Product Change Notification

1. ECN #: 240038

- PESC - VERTICAL POWER SOCKET

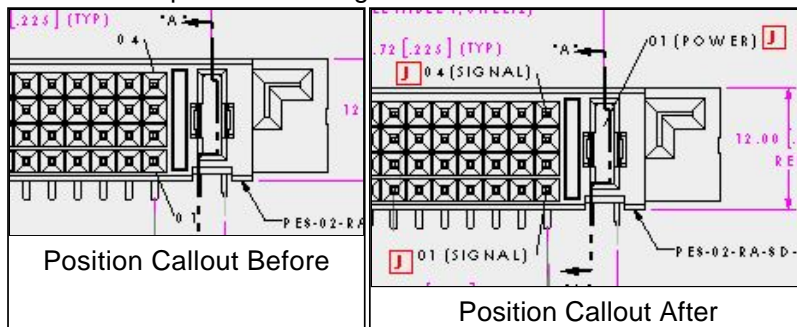
Samtec is adding Positional Callouts to the Power contact system.

- Form - Power Position Callout
